**Title:** Permit 20-455: St. Stephen's Episcopal Church - 4439 West 50th St., Edina

**Prepared by:** Name: Tom Dietrich  
Phone: 952-473-2855  
tdietrich@minnehahacreek.org

**Recommendation:**

1 DEMOLITION AND EROSION CONTROL PLAN

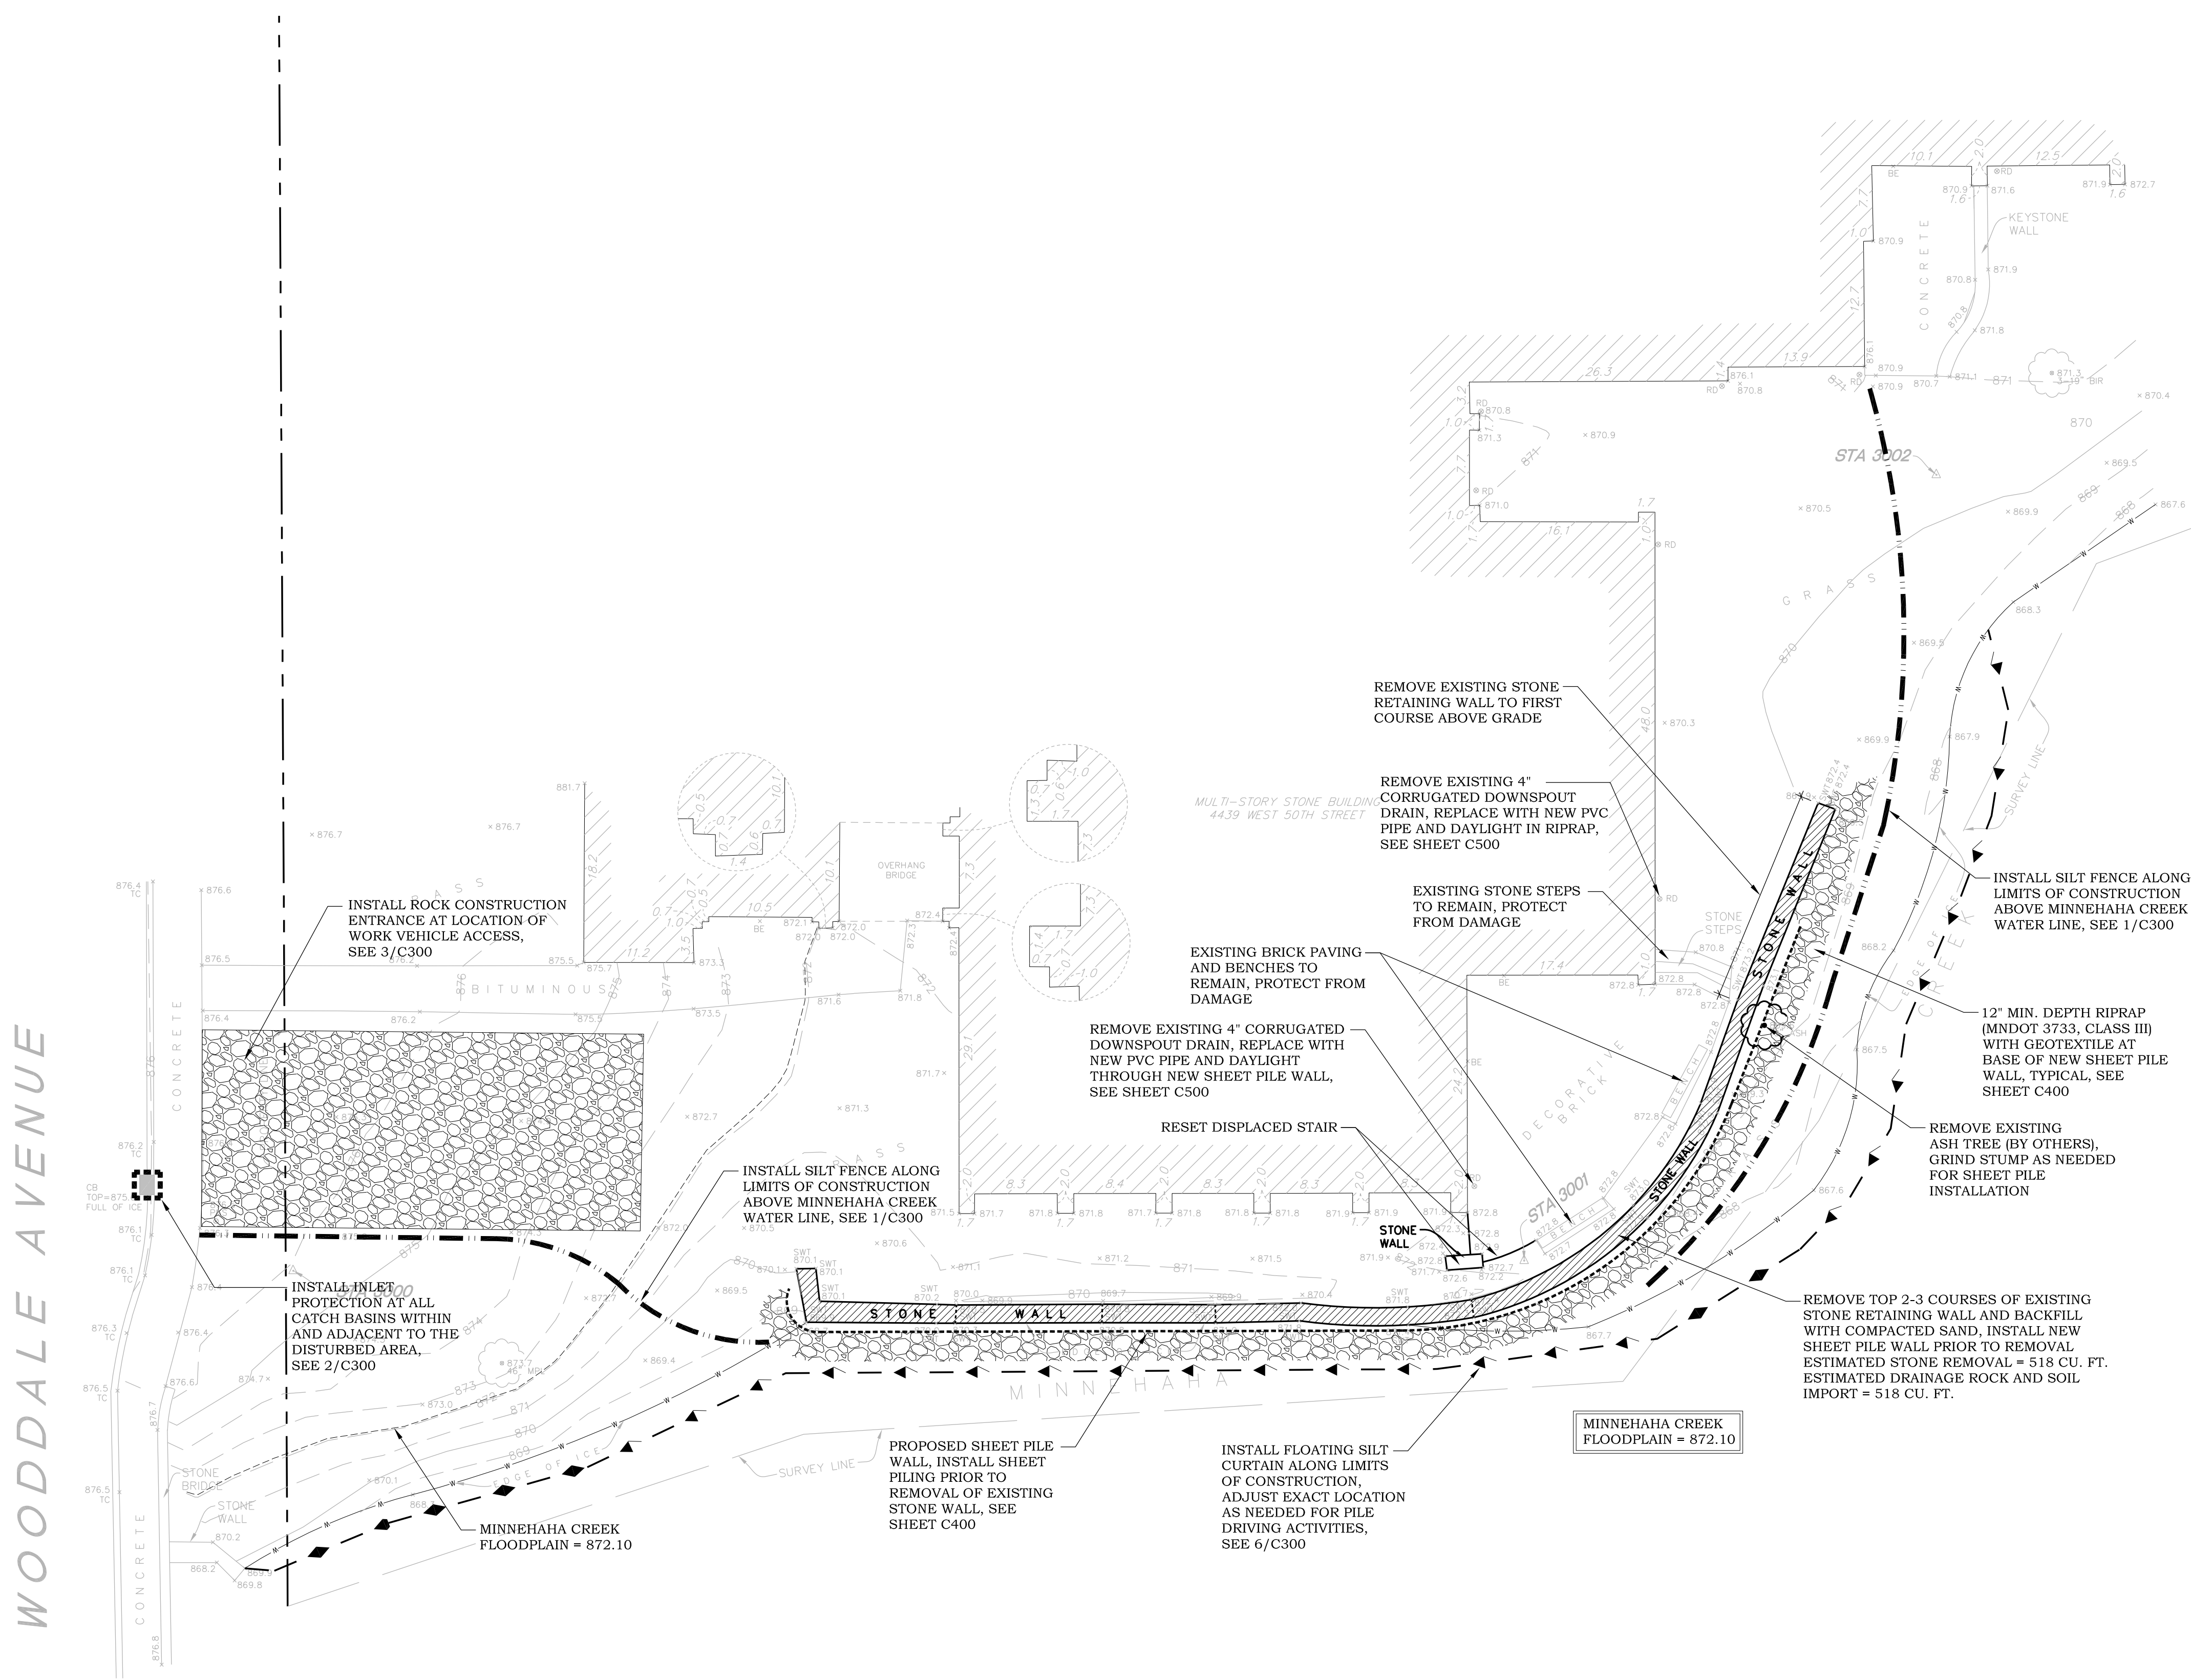
- 6(a)(9) – any work below the ordinary high water level requires encirclement by a floating silt curtain.
  - The Applicant has provided an erosion control plan outlining floating silt/sedimentation curtain sufficient to protect the creek. Therefore, this criteria has been satisfied.
